MONTGOMERY COUNTY PLANNING DEPARTMENT
THE MARYLAND-NATIONAL CAPITAL PARK AND PLANNING COMMISSION

MEMORANDUM

REVIEW TYPE: Site Plan Review
CASE #: 820060330
PROJECT NAME: Petruccelli's Corner
APPLYING FOR: Approval of 10,000 gross square feet office/retail building
REVIEW BASIS: Div. 59-D-3 of Montgomery County Zoning Ordinance

2 REAR ELEVATION
Scale: 1/8" = 1'-0"

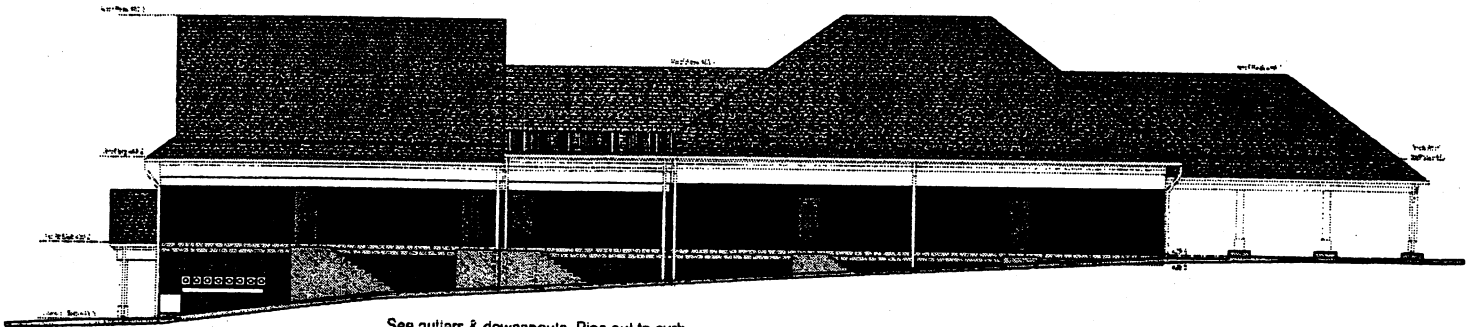
See gutters & downspouts. Pipe out to curb

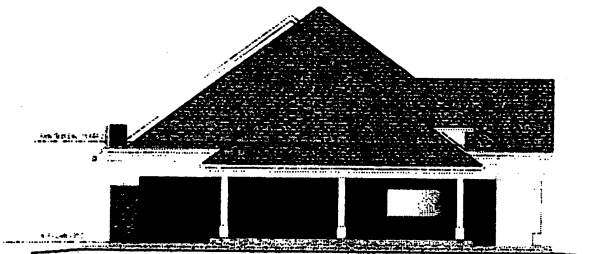
Locate Incoming Services. Provide Enclosure for Elect Meters
